## Product Recall

Subject: RECALL 10V-486/10V-487 National Driver's Seat Pedestal

Technical Service Bulletin  
NSC22955401  
Seat Shock Replacement

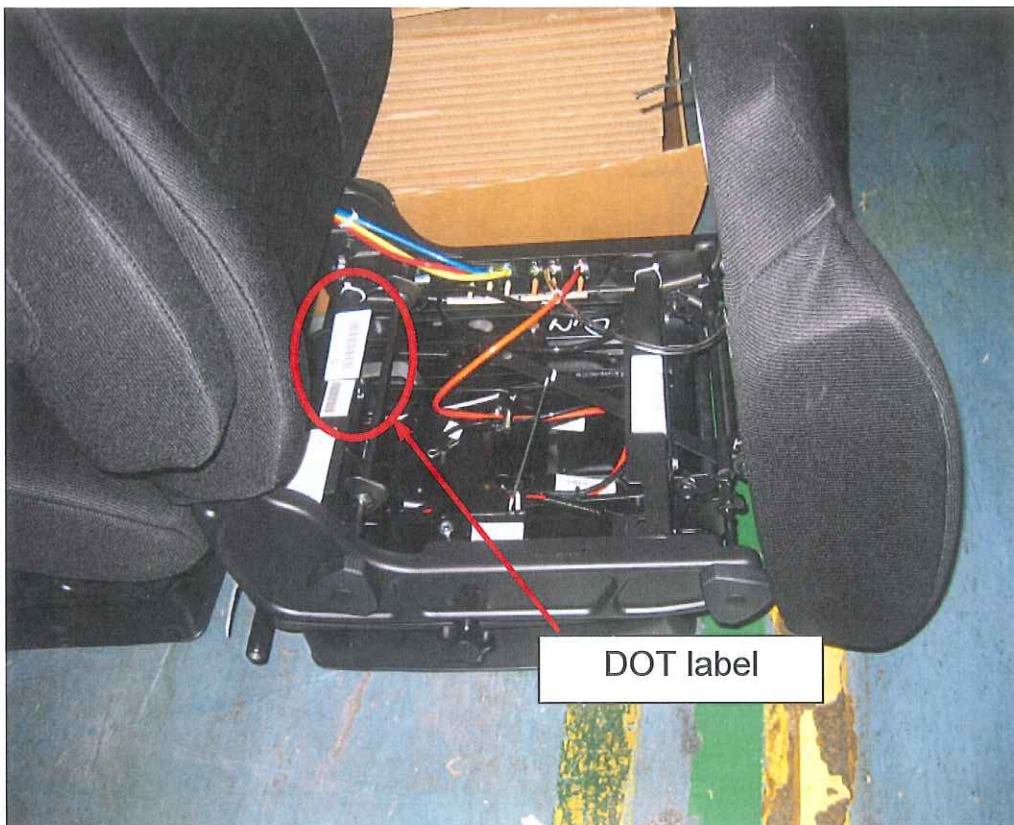
This bulletin provides instruction to inspect and replace the seat shock if it is within the recall period.

Component: Seat Shock

Manufactured by: Stabilus

Part number: 5561ED

Description: BLOCK-O-LIFT

Affected Manufacture dates: 3/10/2009-12/04/2009 (Day 069-Day 338)

## Shock Replacement Procedure

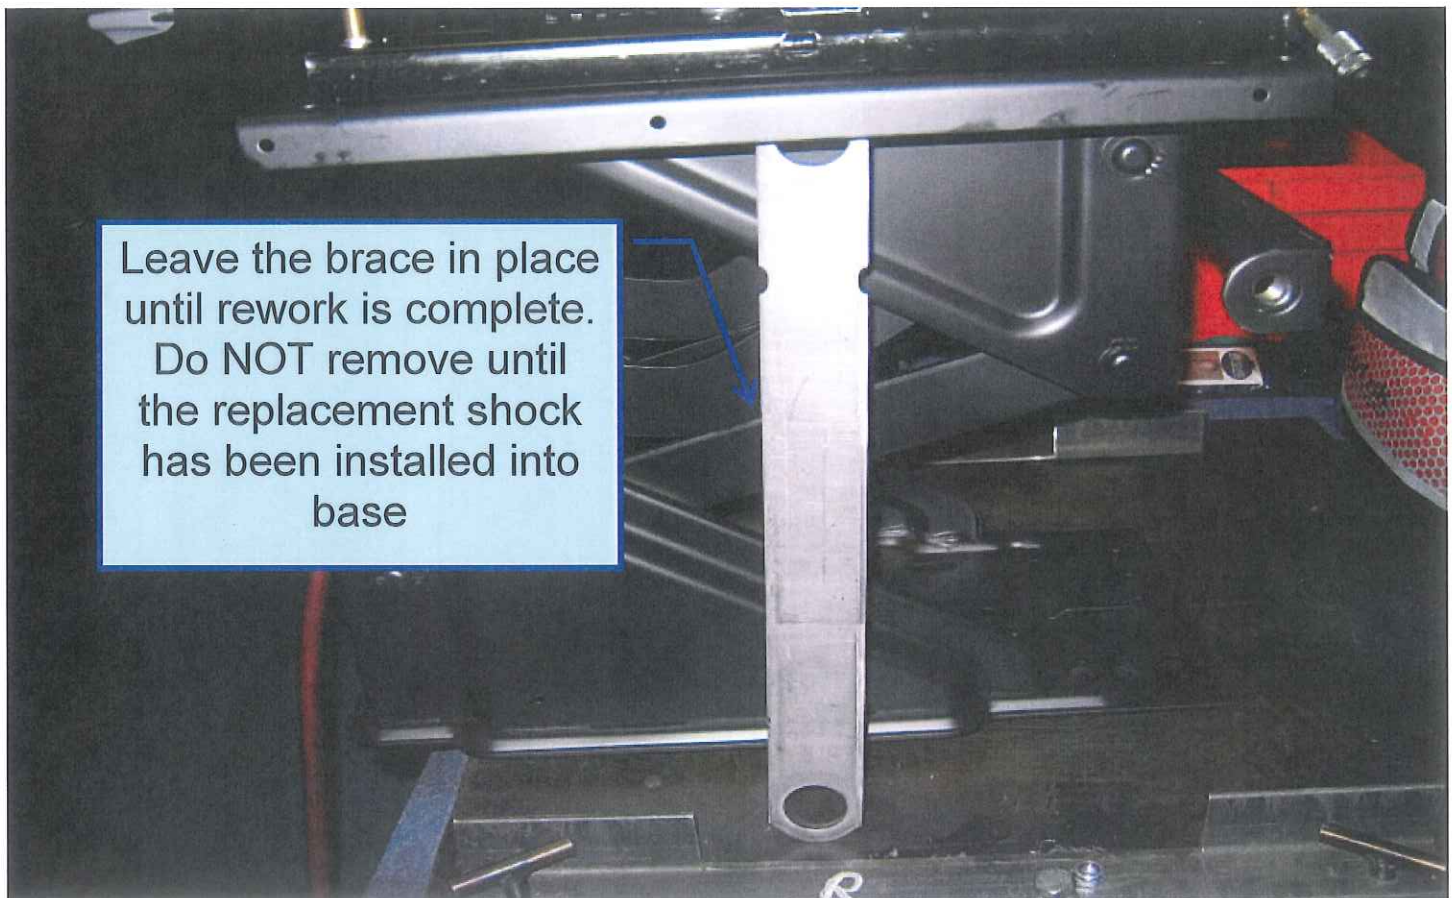
Fully extend base & brace with a bar or block of wood to keep the base at full vertical travel.

## Step 2

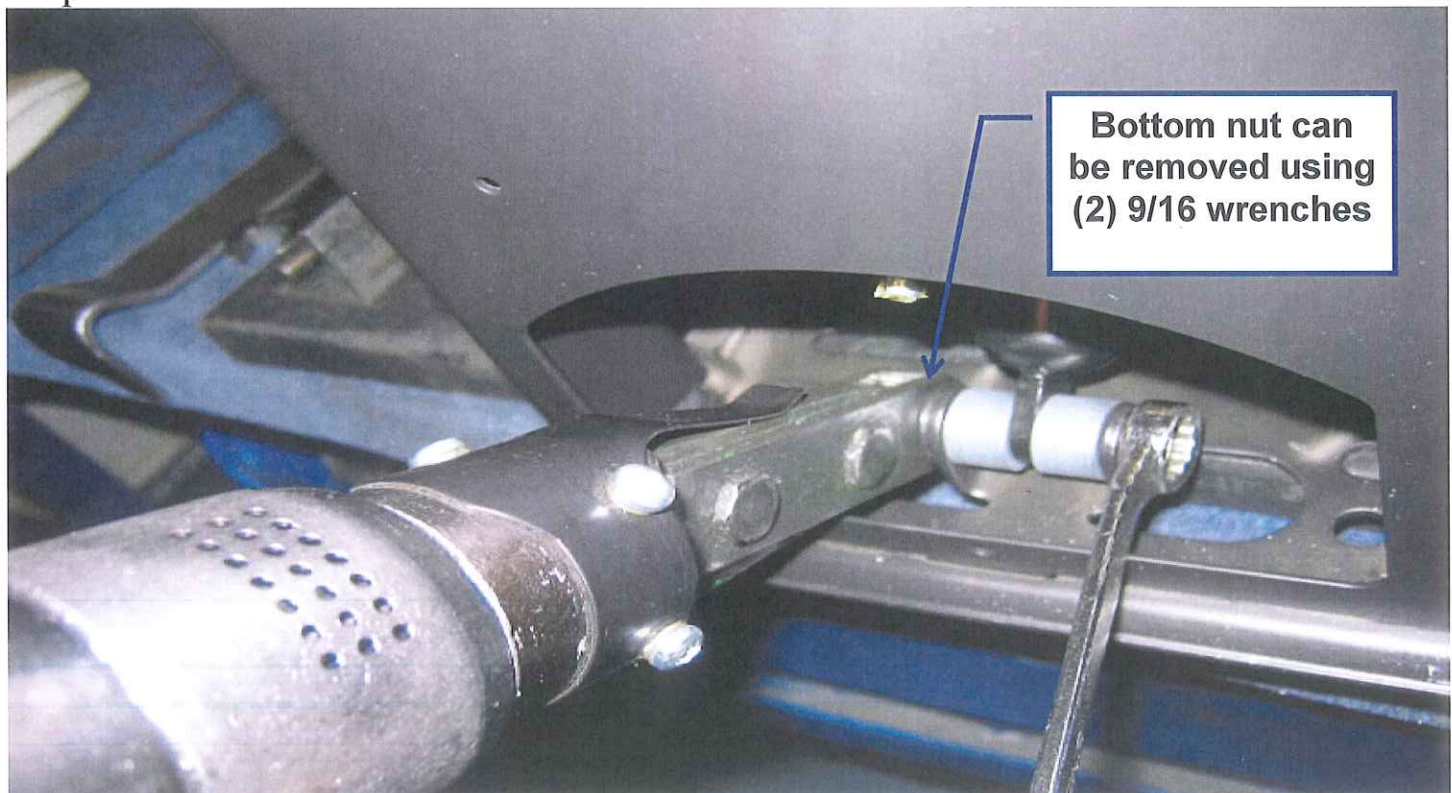
Once the seat base is blocked up at full extension, remove the cable from the release lever.

## Step 4

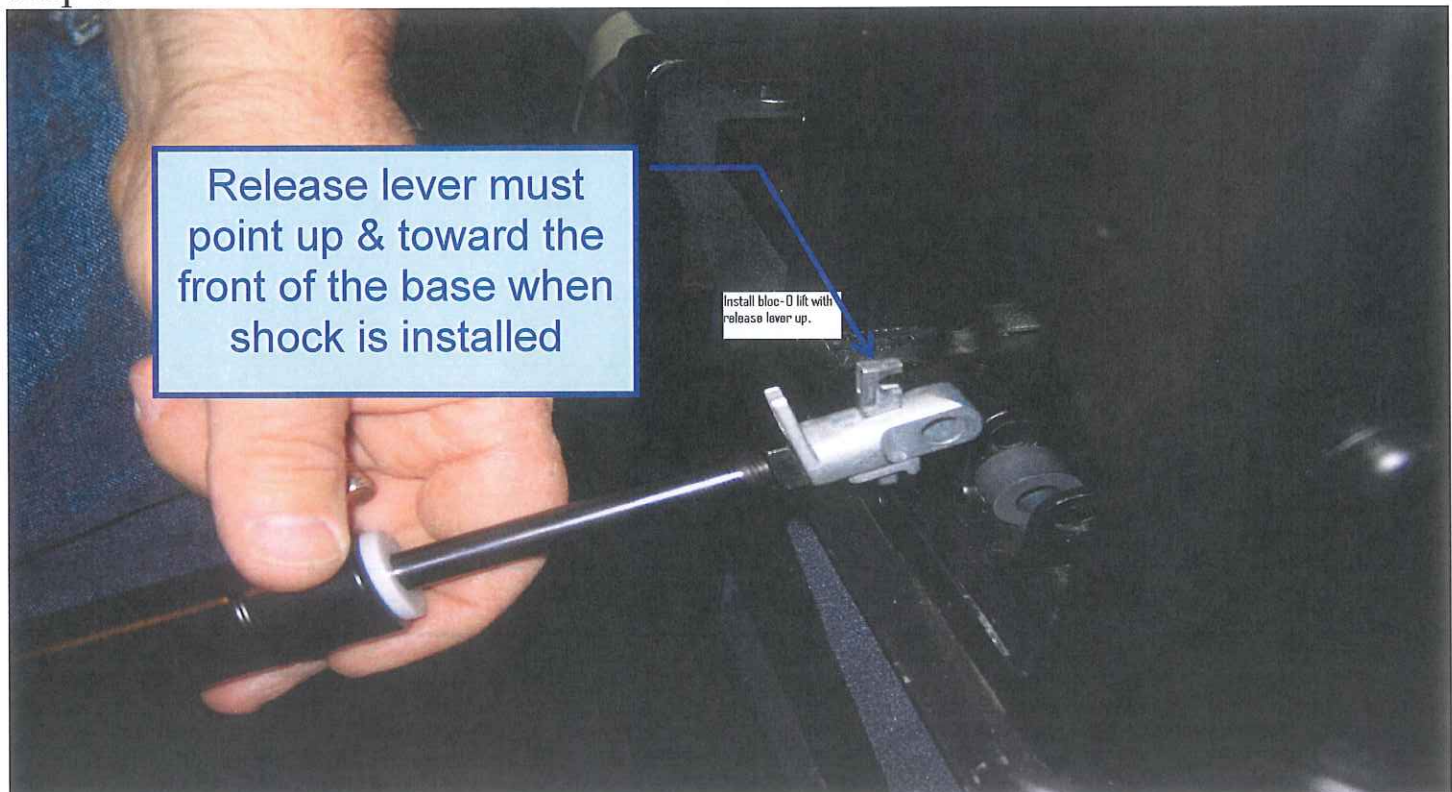
Remove the nut and bolt from top shock mount using (2) ½” wrenches. Then remove the bolt from the bottom mount and remove the shock from the base.
